## Service Bulletin

### Battery Overheating Issue

- To inform about the addition of a thermostat in the DX-D 100 / DX-D 100 Wireless that prevents overheating of a battery and the adjacent batteries during the charging process.
- To inform about availability of the corresponding new schematics.

Figure 8

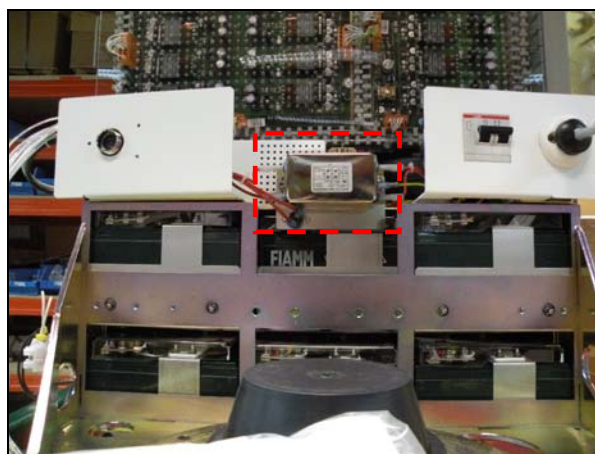
- (10) Mount the thermostat on the support which is fixed at the mobile location shown in figure 10 (dotted red line).

Figure 10

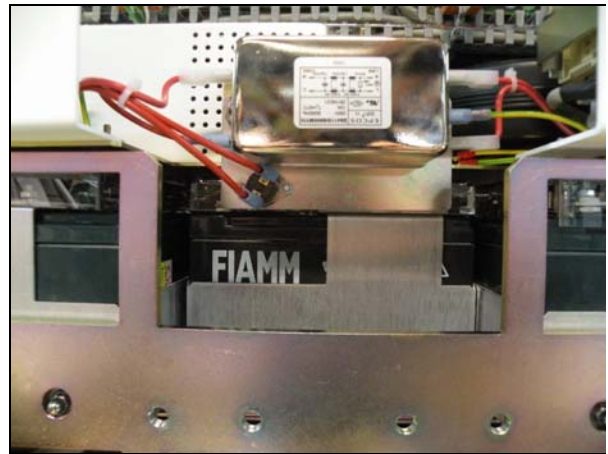
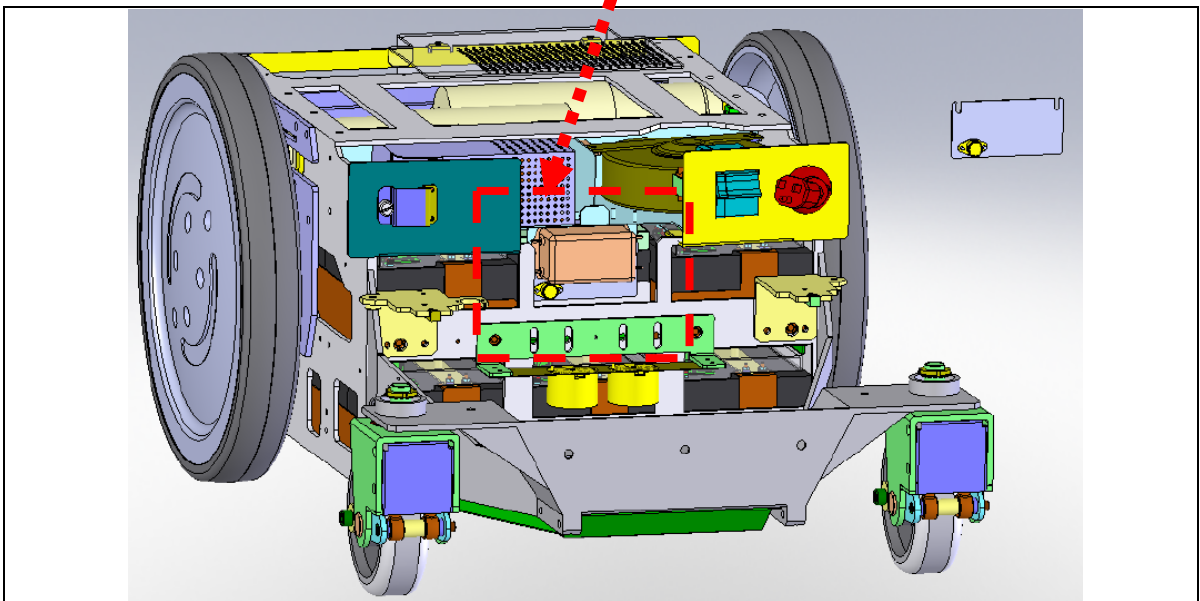
- (11) Figure 11 shows the position of the bracket (with the installed switch) mounted behind the line filter in greater detail. The area marked with a dotted frame in figure 12 corresponds exactly with the detail in figure 11.

Figure 11

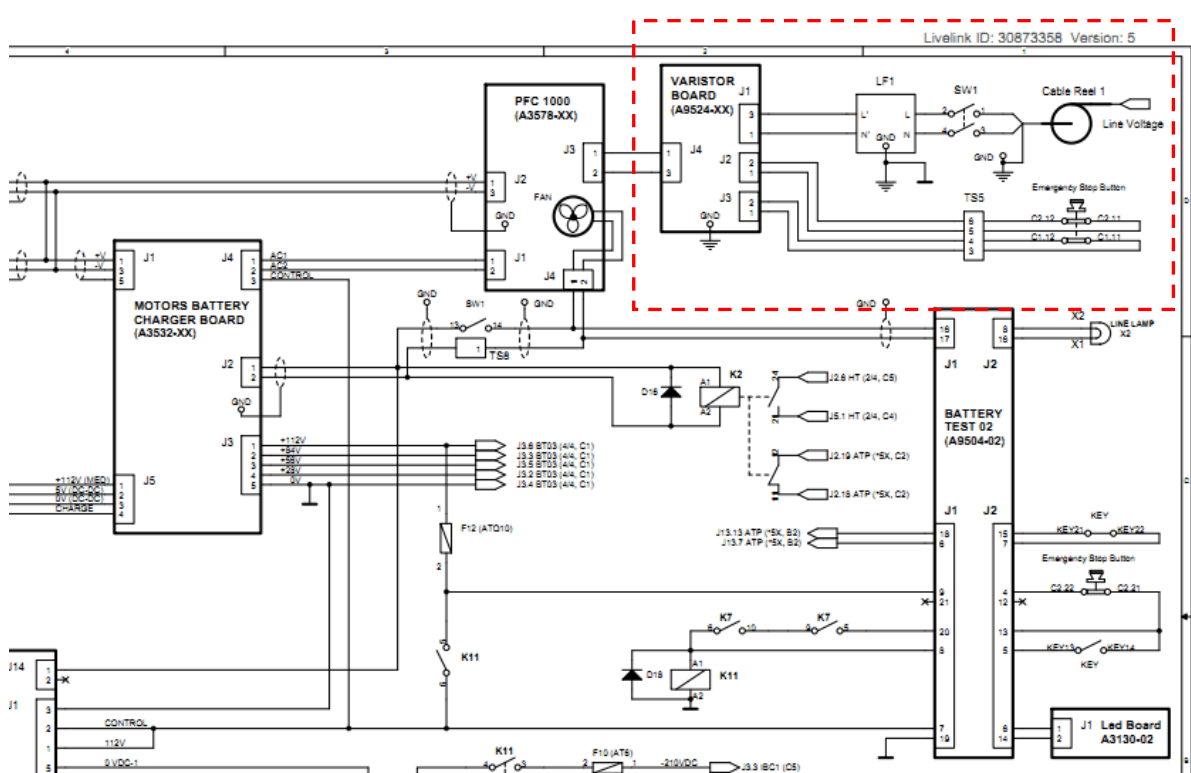
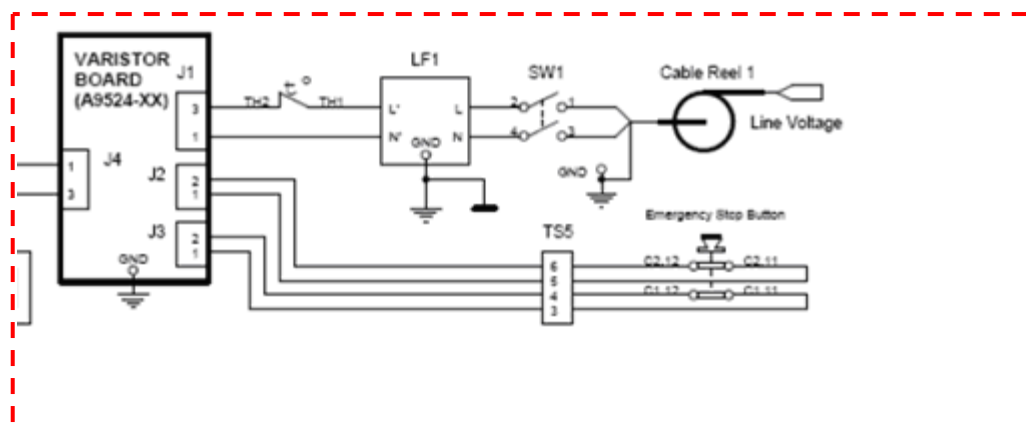
The following two figures show the complete wiring diagram (fig. 13) and the relevant detail which shows the new wiring layout with the built-in thermostat (figure 14).
